HPK MOTO

New HPK PRODUCTS

HPK discs kit → 208.9737.52

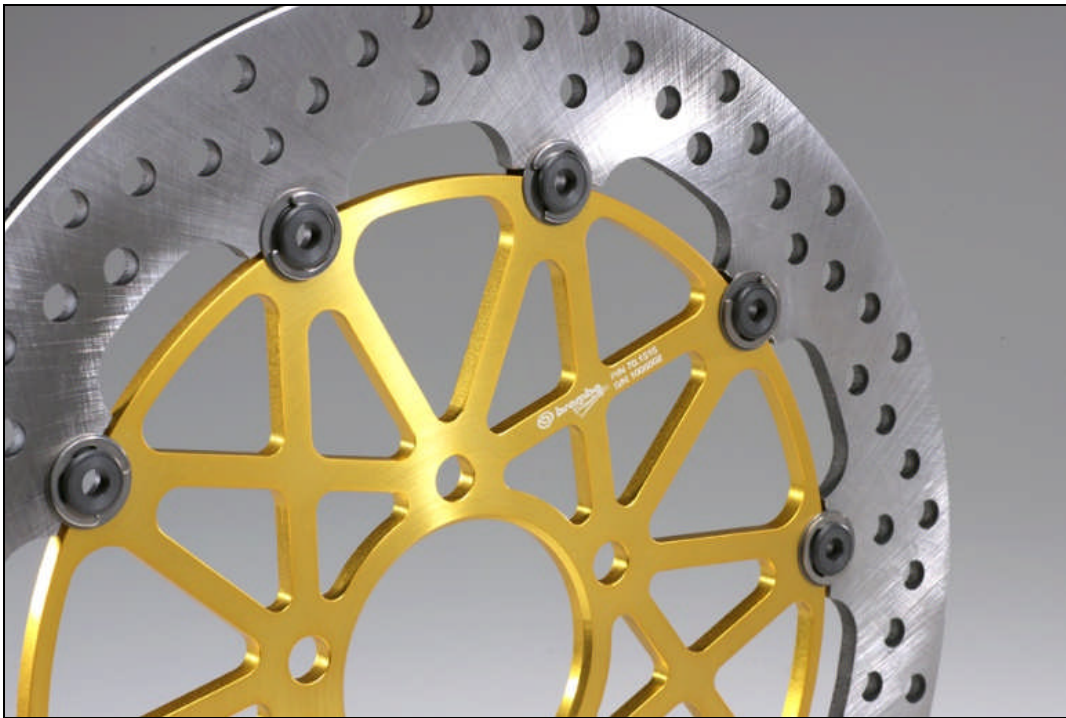
This kit is interchangeable with the 208.9737.10 / 208.A985.10 kits but, having the steel bobbins, avoids all the potential interferences between the bobbins and the Brembo 4 pad calipers:
